WATER DISTRIBUTION SYSTEM
to serve

HEALTHCORE CLINIC

**AS BUILT PLANS
CONTRACTOR: CK CONTRACTING
FOREMAN: OSMAN AMAYA
INSPECTED BY: JACOB MORRIS,
SCHWAB EATON
PDF BY: JCM 08/14/17**

sheet
CV4.0
PPW TITLE SHEET

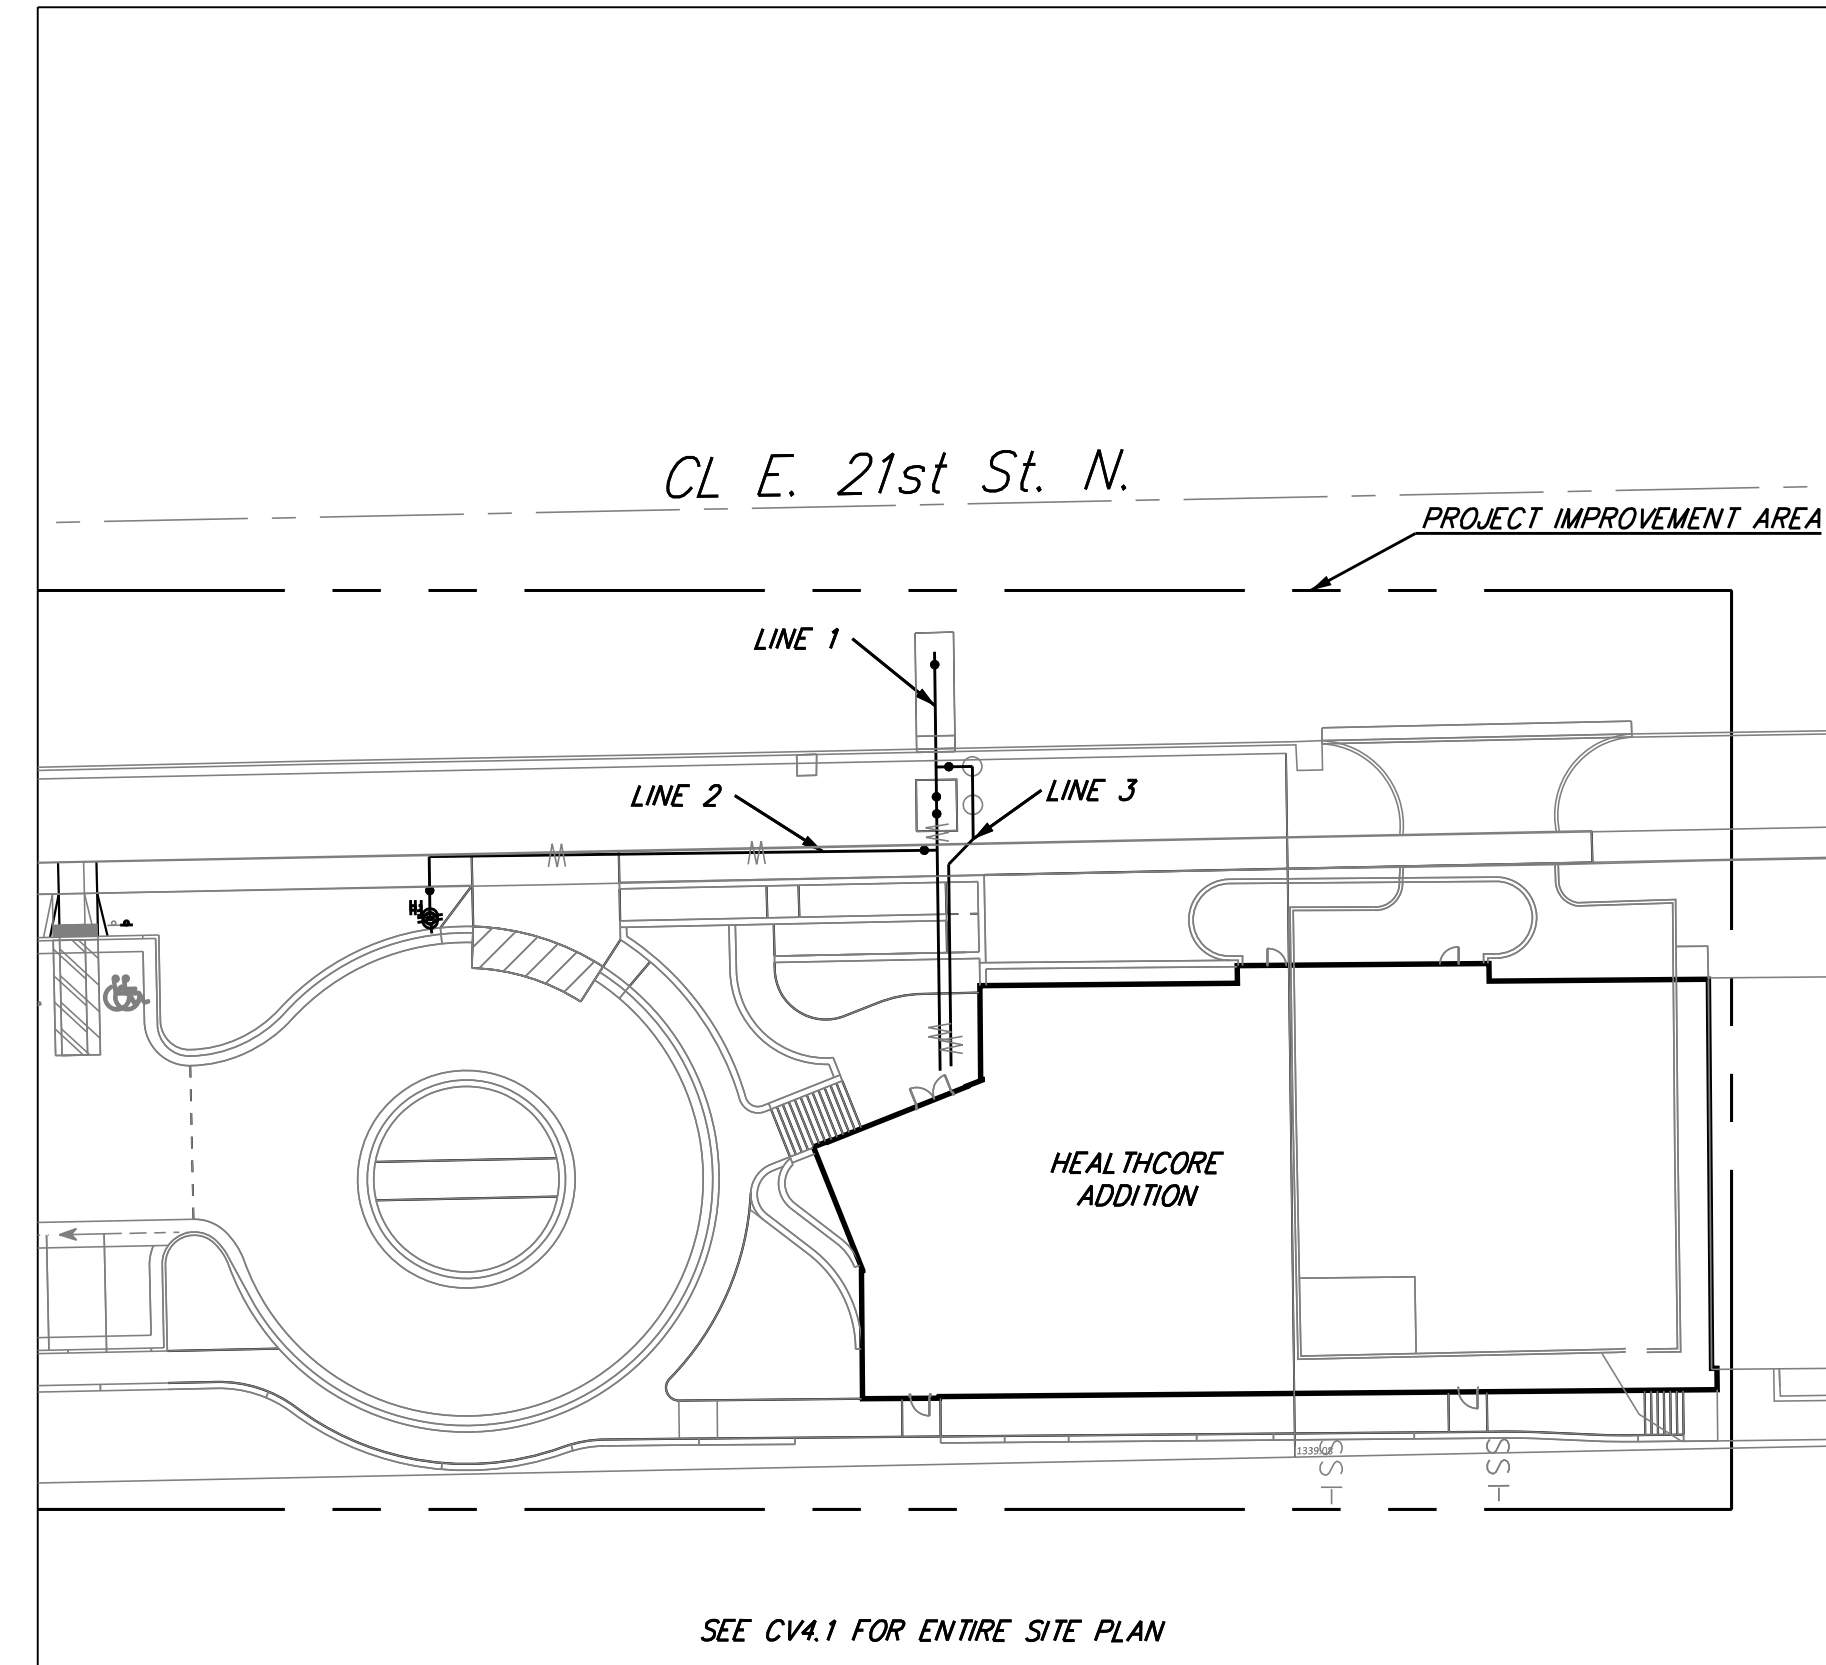
**DETECTOR METER IN VAULT.
METER NO. 17148815
METER READING. 0000000**

sheet
CV4.1
SITE PLAN

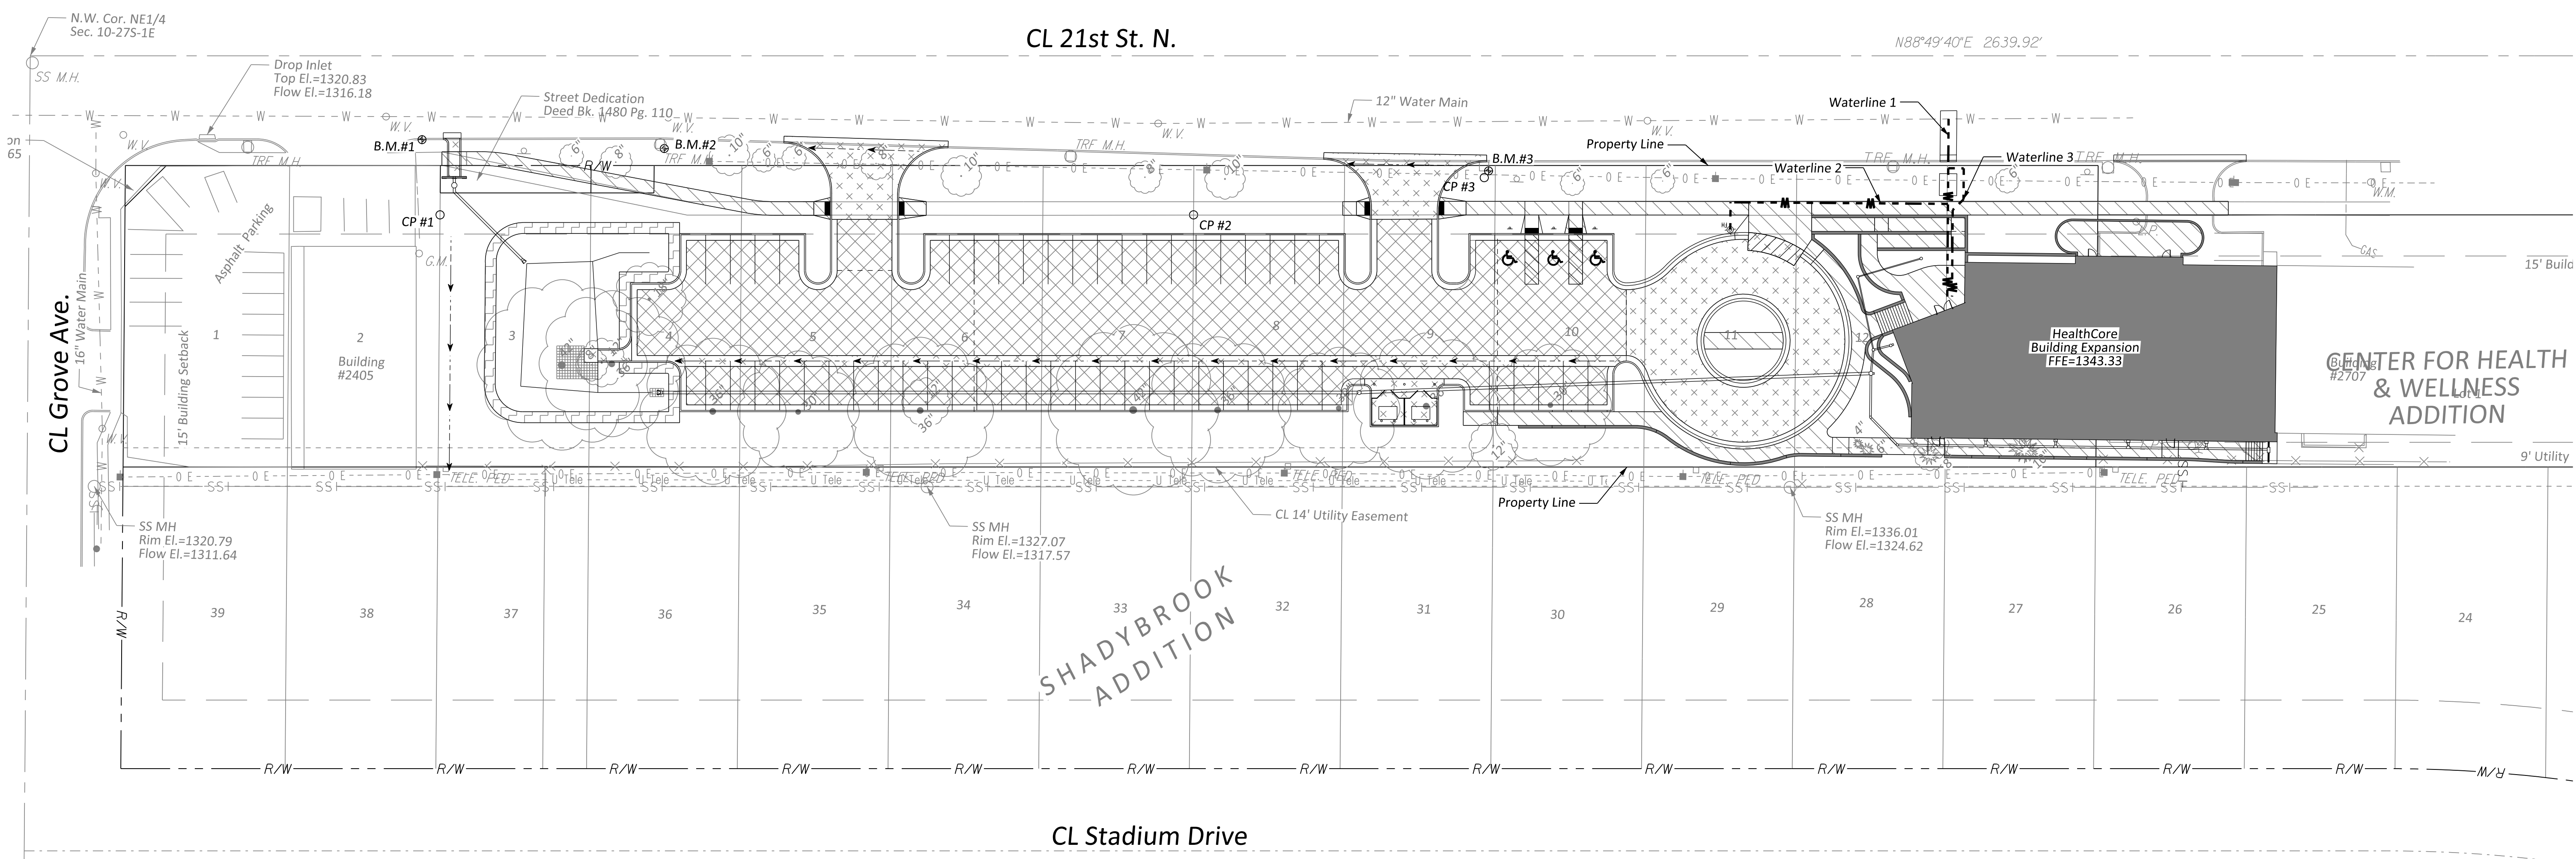
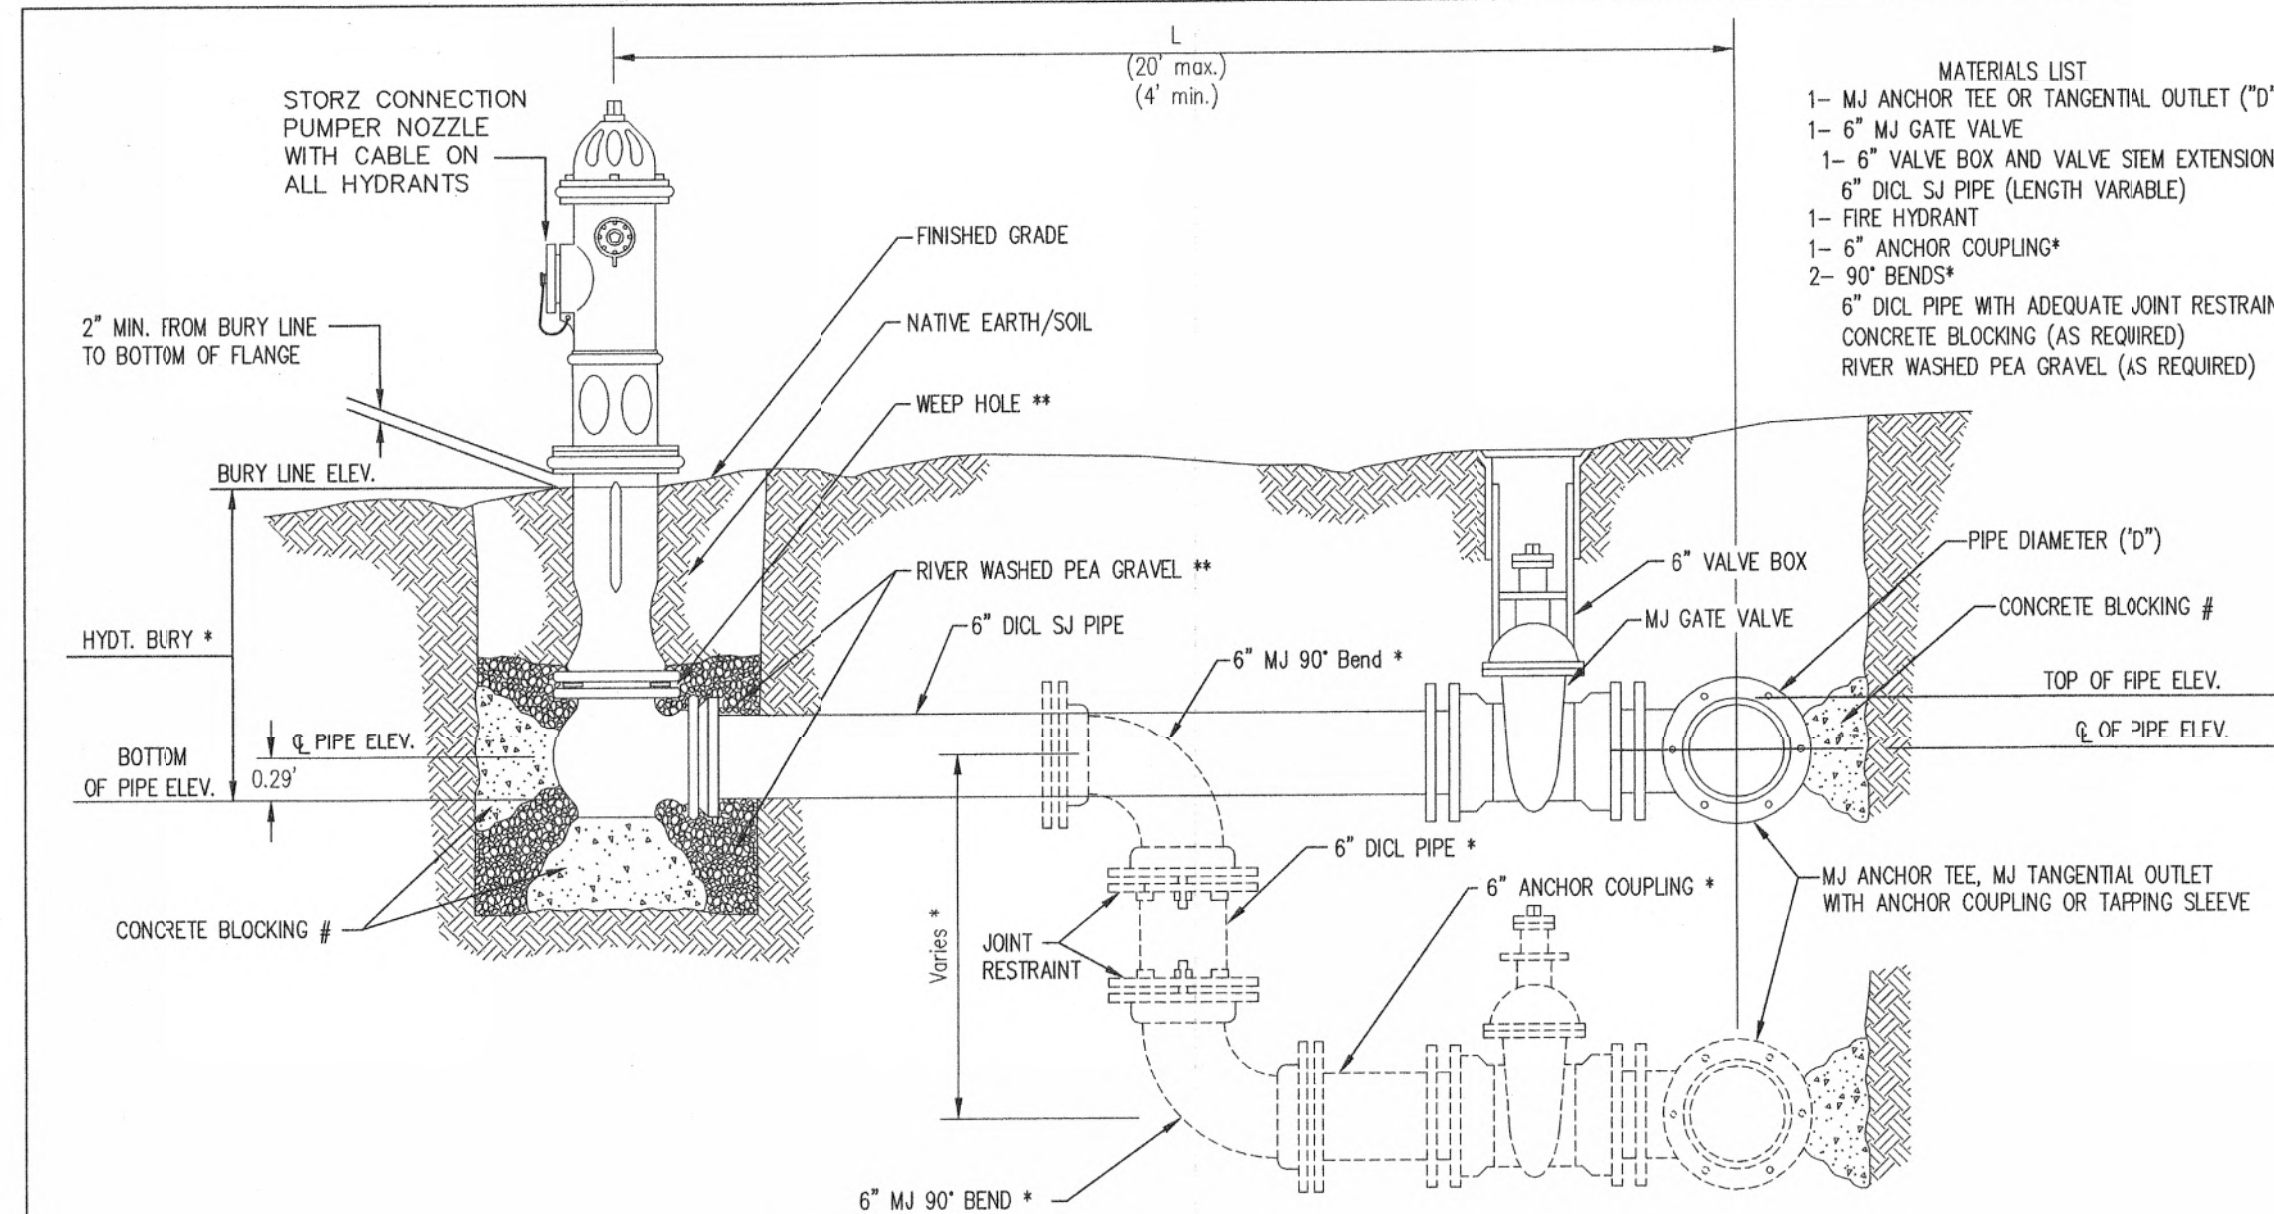
TAPPING VALVE IS 15' S & 90' W OF CENTER LINE OF 21ST N & PRINCE AND ALSO 15' N OF THE BACK OF SOUTH CURB ON 21ST N.

FIRE VAULT IS 90' W OF CENTER LINE OF PRINCE & 8' S OF THE BACK OF SOUTH CURB ON 21ST N.

FH IS 77' W OF CENTER OF VAULT & 25' S THE BACK OF SOUTH CURB ON 21ST N.

FH VALVE IS 9.5' N OF FH.

BUILT TO PLAN
